# City of Kenmore, Washington

### RE: Development Review Team Pre-Application Meeting Draft Comments O'Brien Townhomes; 6 Units / PRE26-0003 (PRJ26-0003)

**Date of Report:** February 12, 2026  
**Permit Number:** PRE26-0003  
**Project Name:** O'Brien Townhomes – FINAL Pre-App Comments  
**Project Location:** 6330 NE 181<sup>st</sup> Street (Parcel no. 618170-0190)  
**Reviewer:** Reilly Rosbotham, Planner  
**E-mail Address:** [rrosbotham@kenmorewa.gov](mailto:rrosbotham@kenmorewa.gov)  
**Department:** Development Services – Planning

**Date of Report:** February 11, 2026  
**Permit Number:** PRE26-0003  
**Project Name:** Obrien Townhomes  
**Project Location:** 6330 NE 181ST (Parcel no. 618170-0190)  
**Reviewer:** Doug van Gelder, P.E. – Civil Engineer  
**E-mail Address:** [Dvangelder@kenmorewa.gov](mailto:Dvangelder@kenmorewa.gov)  
**Department:** Development Services – Engineering

**Northshore Utility Map**

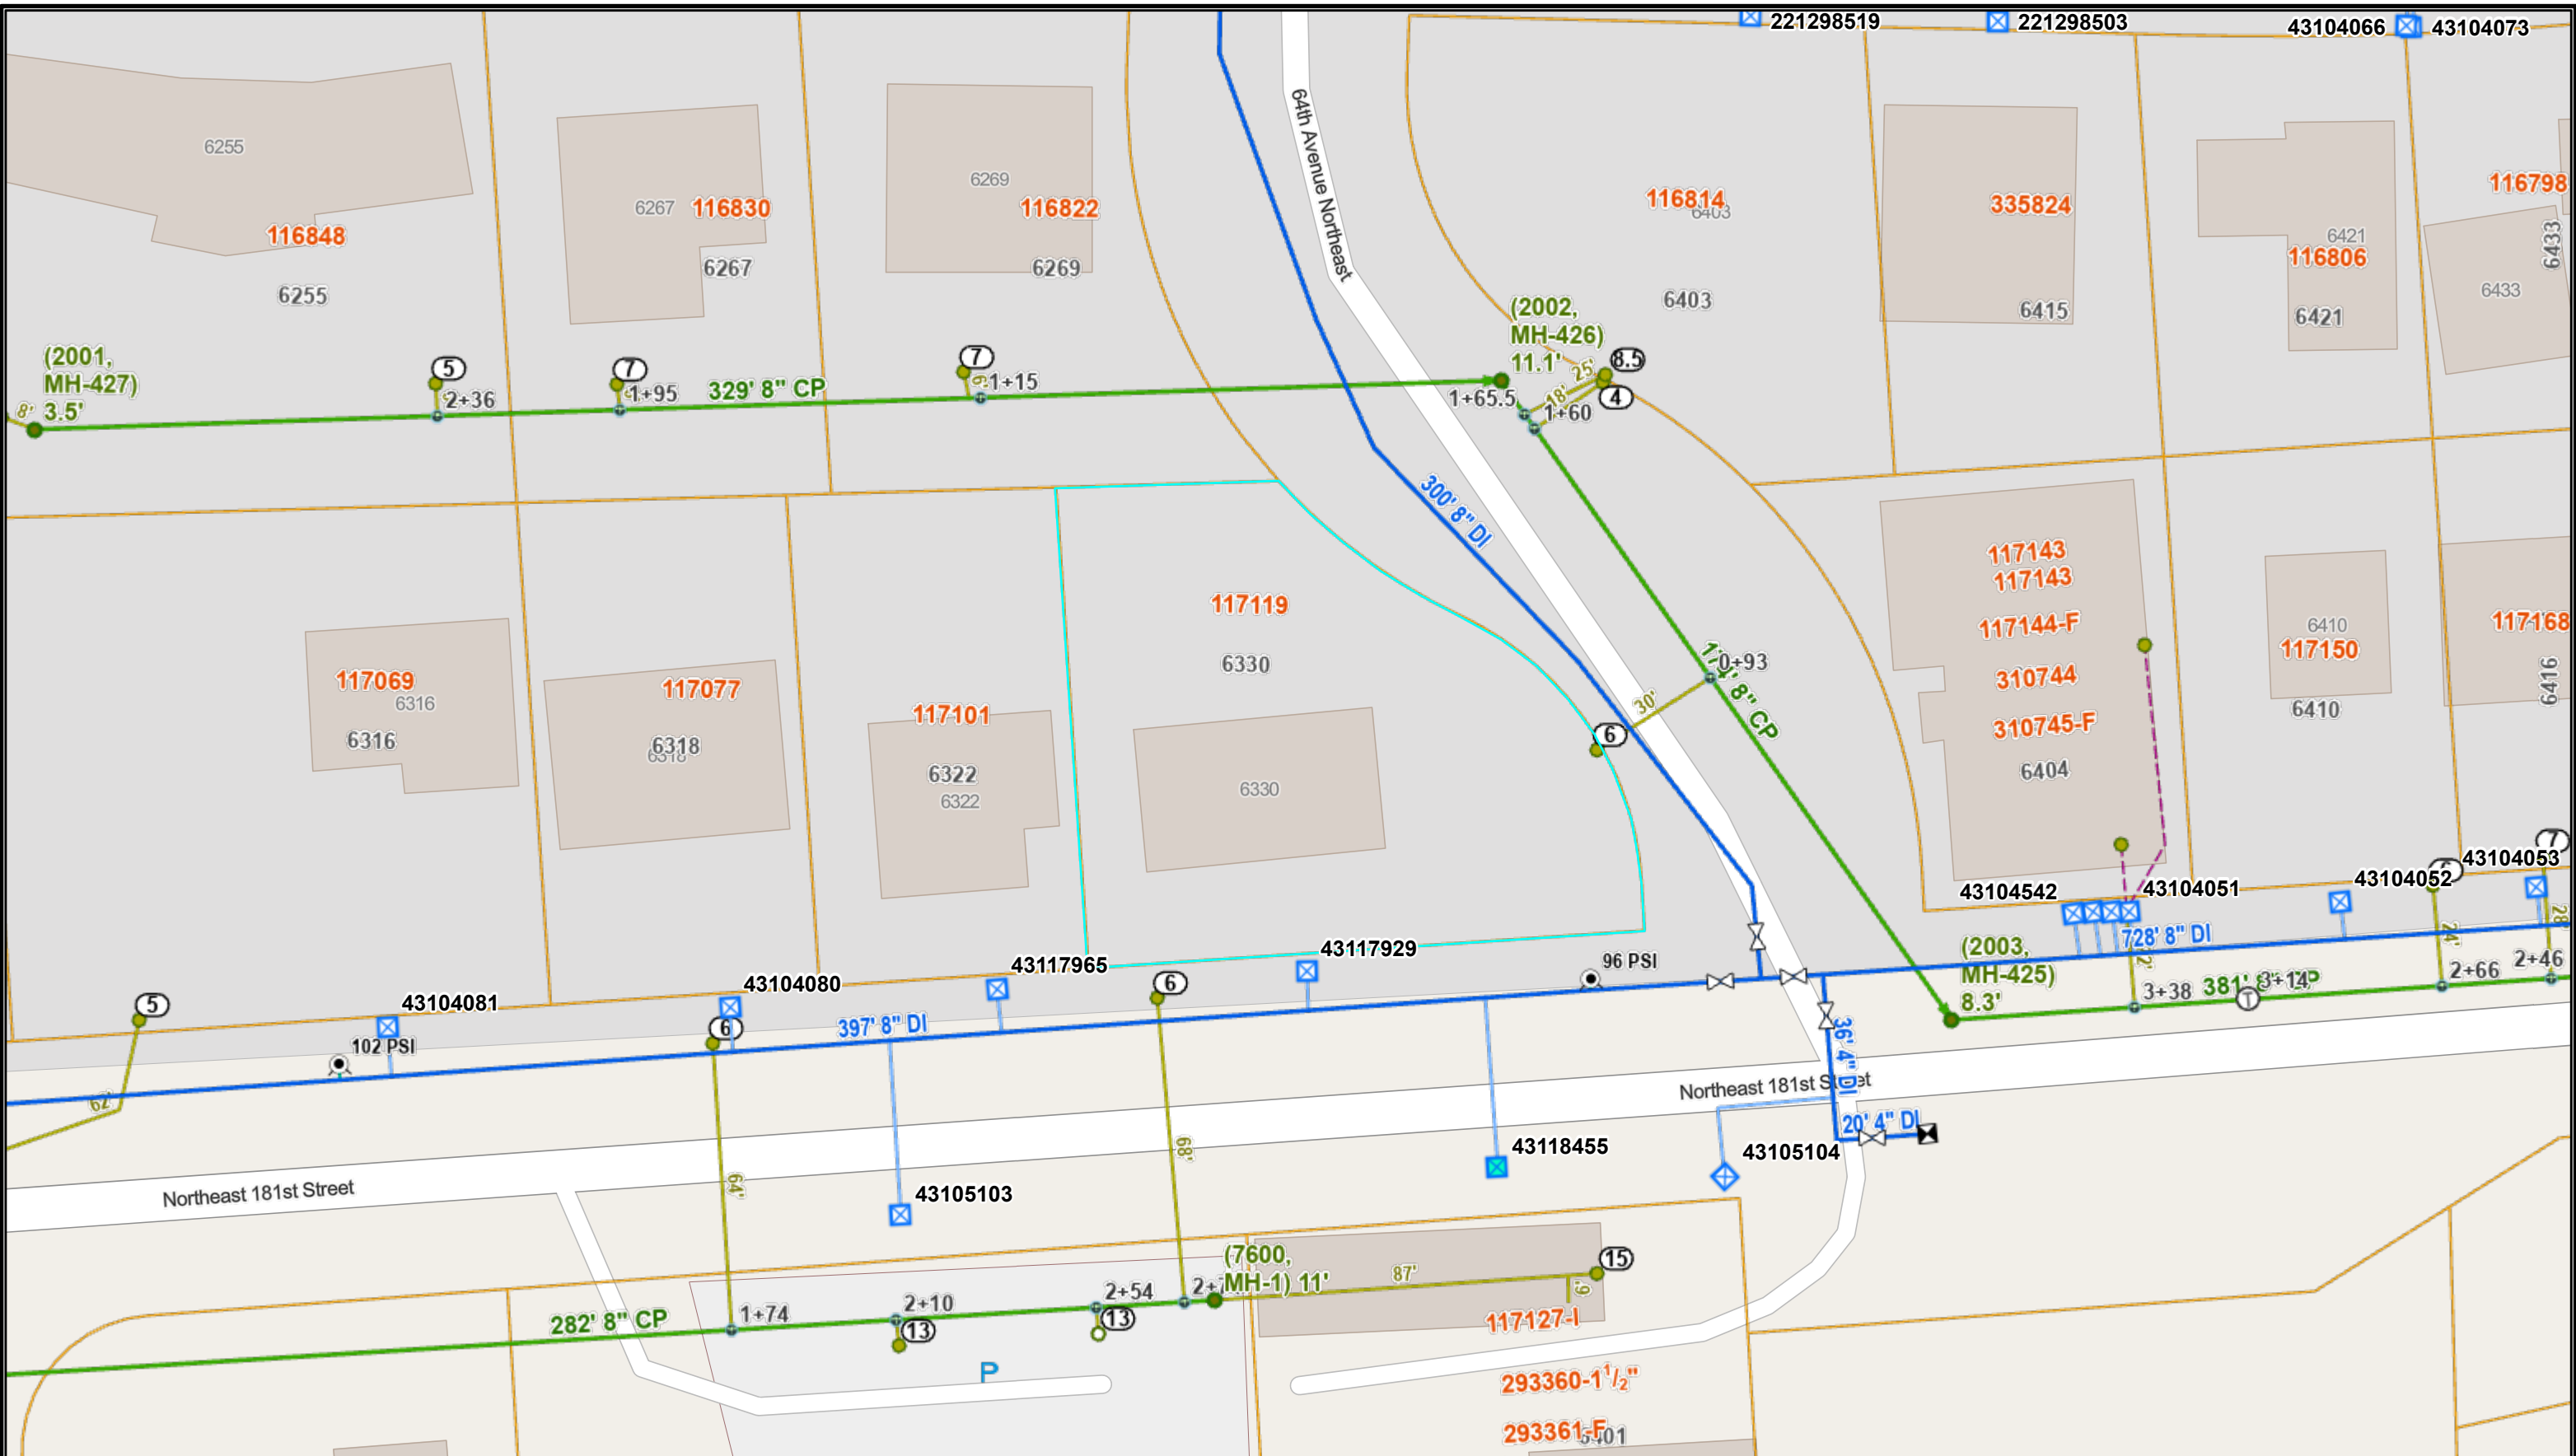
Northshore Utility District policy requires that all units on a property are served by individual water meters; therefore, a new water service installation is required for each townhome. The existing water service cannot be reused due to age and is to be abandoned at the main. District crews will install the new services and abandon the existing in the ROW at the developer's expense. The developer is responsible for connecting the units to the backside of the water meters. Installation of double-check valve backflow assembly devices are required for all 3-story structures. The backflow devices are to be installed directly behind the water meter boxes; the District does not allow the devices to be installed within the homes. Other specific fire related requirements are to be coordinated directly with the Shoreline Fire Dept.

Sewer will require an 8-inch sewer main line extension and a Developer Extension Agreement. Each townhome is to be provided with an individual side sewer stub that connects directly from the new main line to each unit. Side sewer stubs are to be installed as perpendicular to the main as possible. The existing side sewer stub can be reused for Unit 6 if it is in acceptable condition.

The developer is to submit engineered sewer and water plans to the District for review and approval. An application for Developer Extension Agreement is to accompany the plan submittal. The developer is encouraged to contact the District to schedule a pre-design meeting prior to plan submittal.
